Product Change Notification / RMES-16SJKO622

CCB 4550 and 4550.001 Final Notice: Qualification of STAR as an additional assembly site for selected Micrel products available in 4L VDFN (3.2x2.5x0.9mm) and (2.0x2.5x0.9mm) packages.

CCB 4550 and 4550.001
Pre and Post Change Summary
PCN #: RMES-16SJKO622

LEAD FRAME COMPARISON

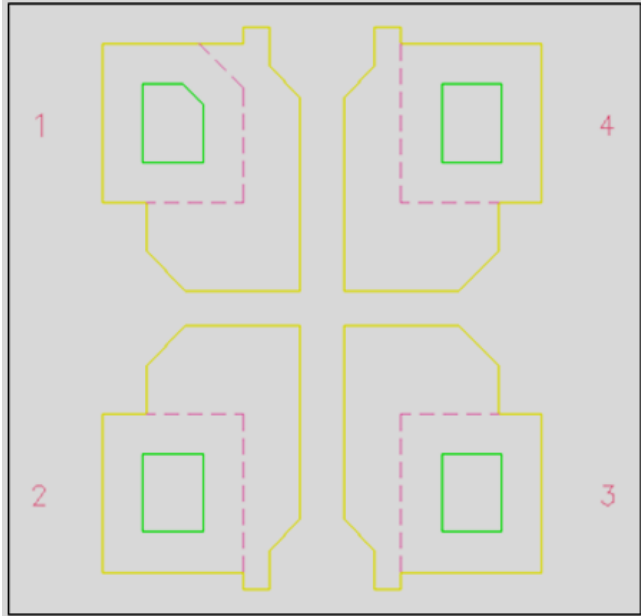
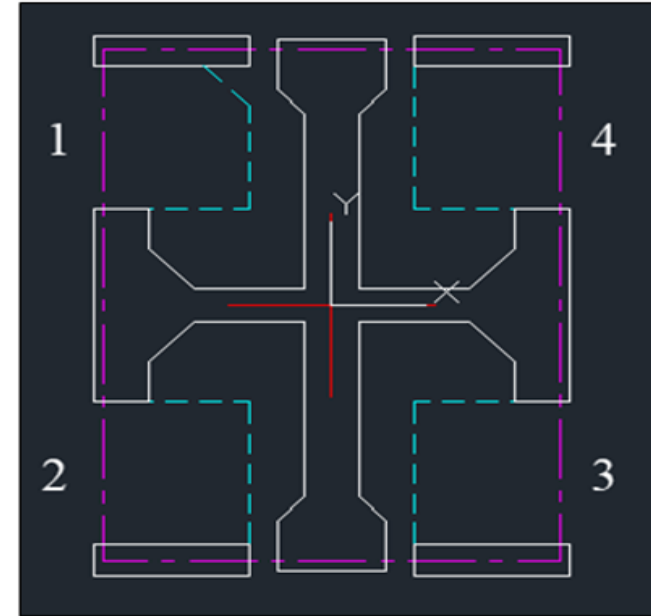
Qualification of STAR as an additional assembly site for selected Micrel products available in 4L VDFN (3.2x 2.5 x 0.9 mm) and (2.0 x2.5 x0.9 mm) packages.

Leadframe Material	A194
Lead Lock (Locking Hole)	No
Lead Plating	NiPdAu

Leadframe Material	A194
Lead Lock (Locking Hole)	No
Lead Plating	NiPdAu
